SUBJECT : ImageQuest Co., Ltd.
FCC ID: PJIL19A0D061
FCC Part 15 Subpart B Certification

Transmitted herewith, on behalf of ImageQuest Co., Ltd. is an application for a FCC Part 15 Subpart B Certification of the following 19-inch LCD Monitor:

FCC ID : PJIL19A0D061
Model : L19A0D061

• Solution for EMI

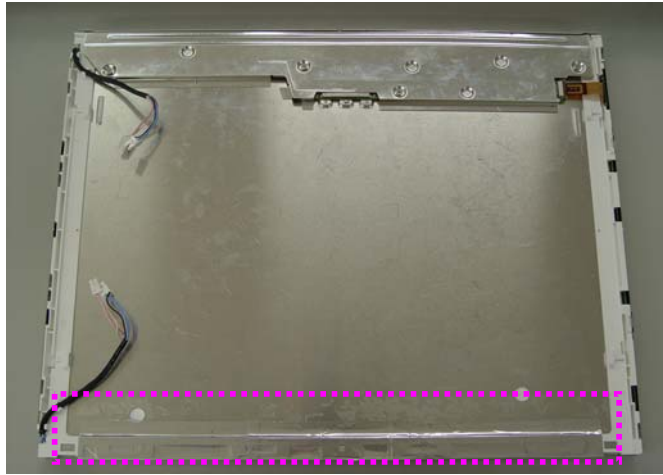
1. Attach a aluminum foil LCD panel Bottom

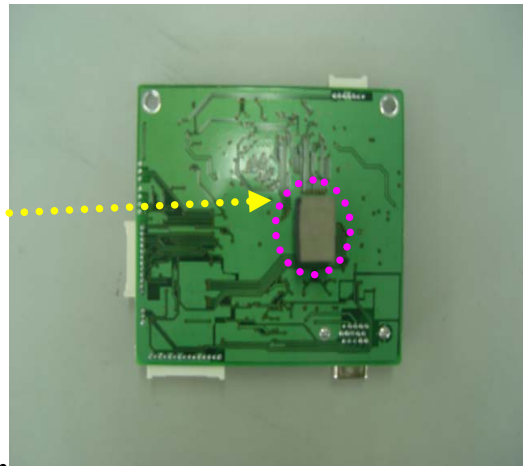
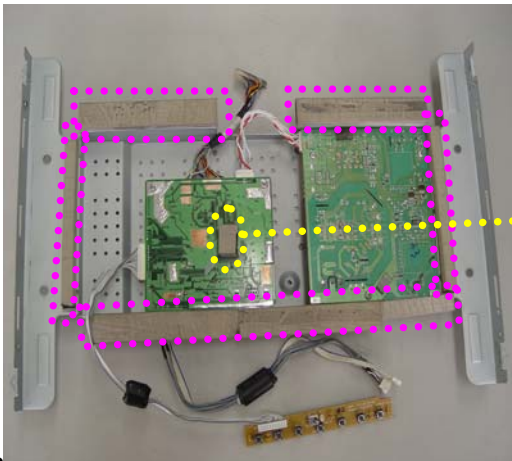
2. Attach a gasket on the Main Board and Main Frame to contact a LCD panel

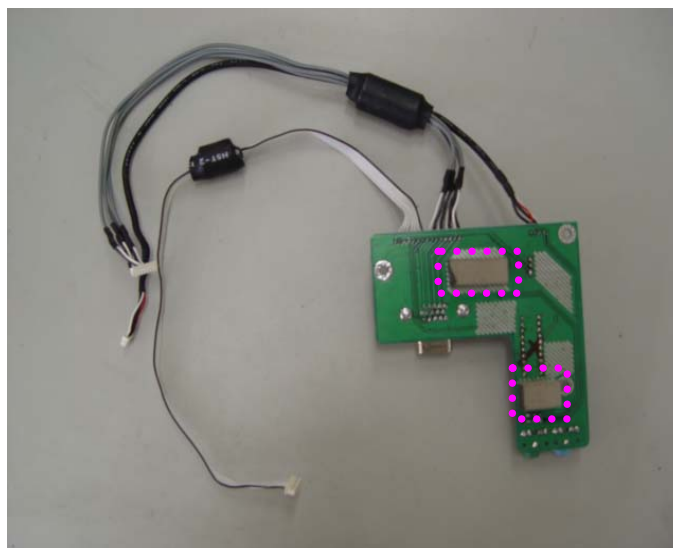
3. Attach a gasket on the Audio PCB to contact a stand

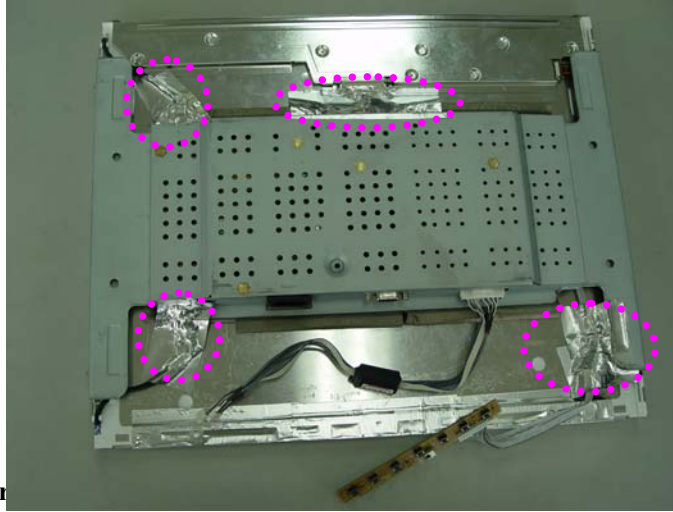
4. Attach a aluminum foil between Main Frame and LCD panel

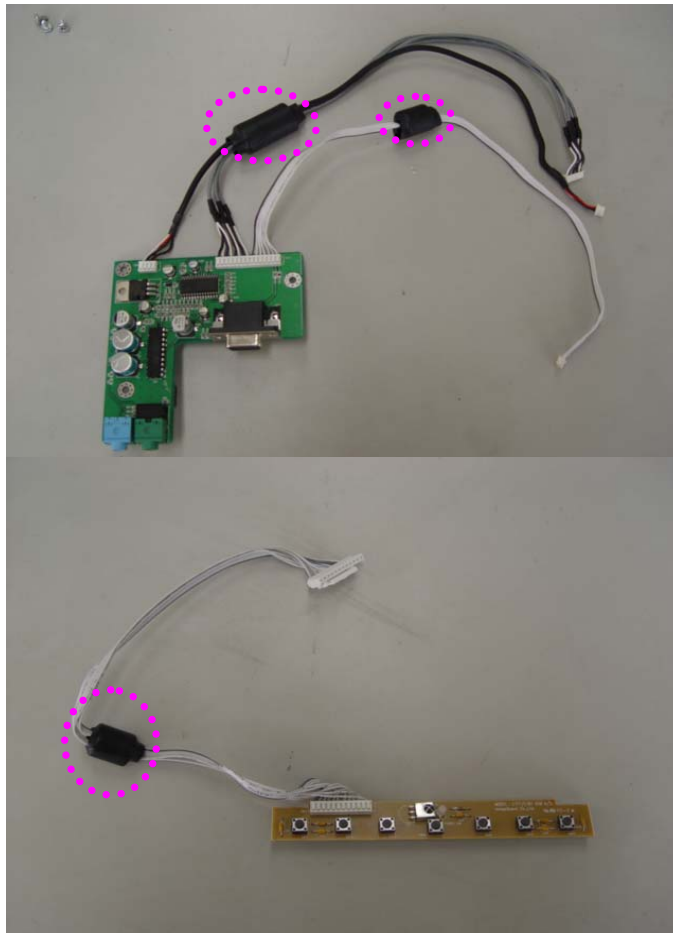
5. Apply a ferrite Core cable
